**From:** Vicki Orrico <Orrico@jmmlaw.com>  
**Sent:** Wednesday, July 20, 2016 2:42 PM  
**To:** Gary Lee  
**Cc:** Sean Miller; Min Luo  
**Subject:** RE: 16390 Cleveland St. Parcel number: 7198800085

**Subject:** 16390 Cleveland St. Parcel number: 7198800085

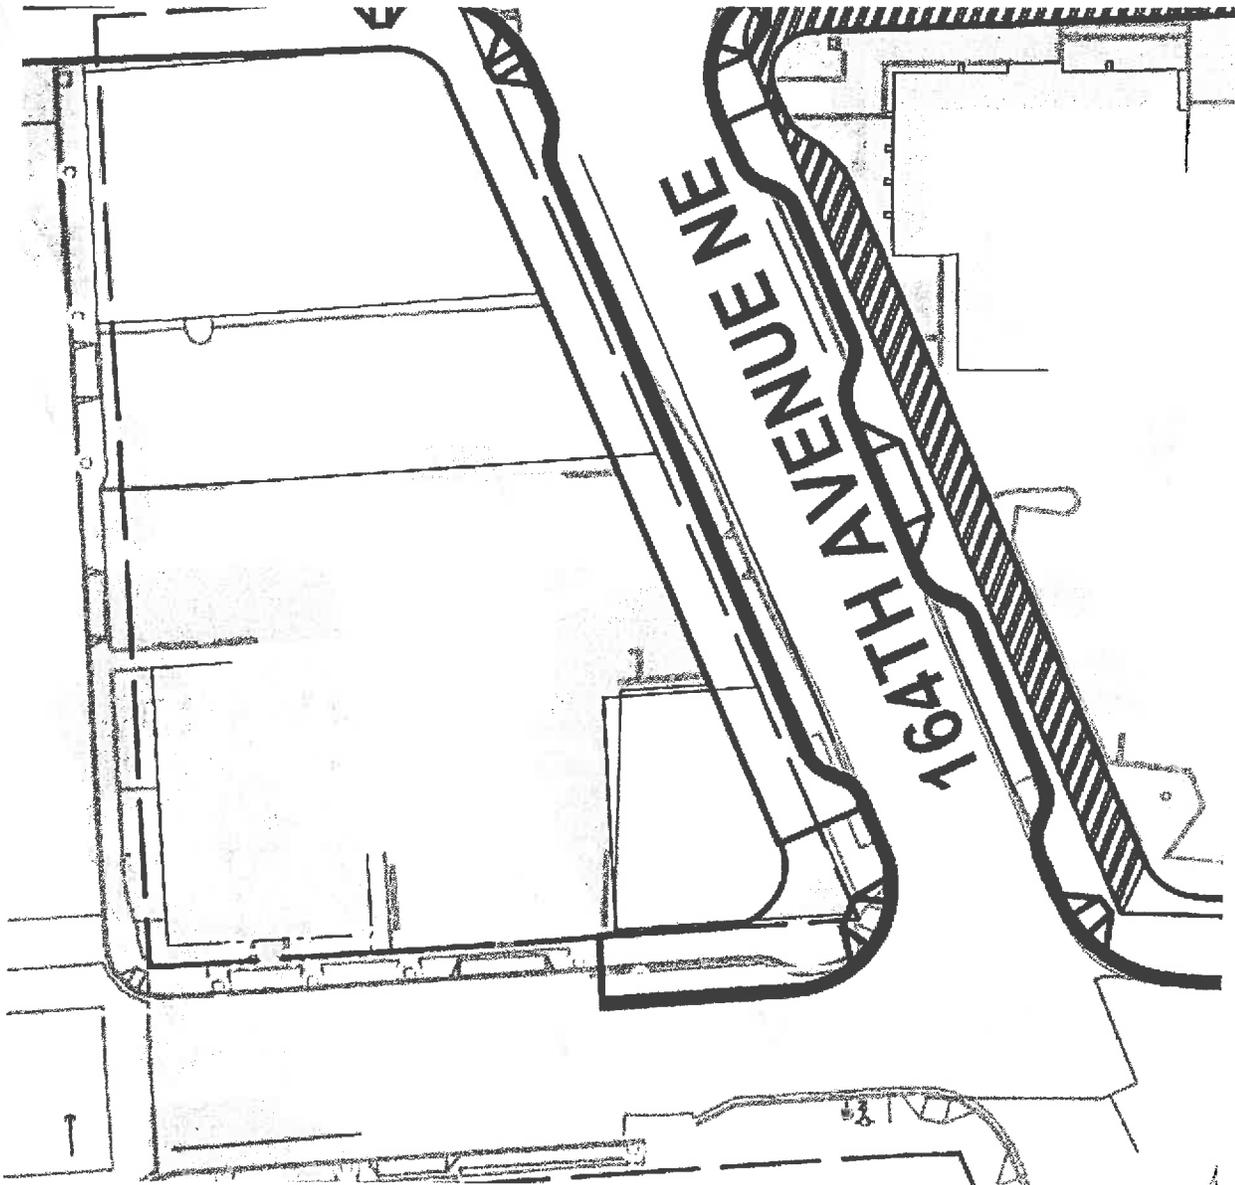
If the cost of the improvements to the building (with your project) equal or exceed \$23,500 (as assessed below) you will need to remove approximately 10' of the east side of the building (fronting 164<sup>th</sup> and the intersection) and build a new, wider, sidewalk as shown below. All of the costs associated with improving the building will be included.

Our general thinking is that you will be spending at least \$23,500 to make the building suitable for retail/commercial use, which will trip the requirement for the removal of the east side of the building and widening of the sidewalks. I think that this is very important for you to aware of.

Plans for this intersection call for the widening of the sidewalk as shown below. See arc through the building.
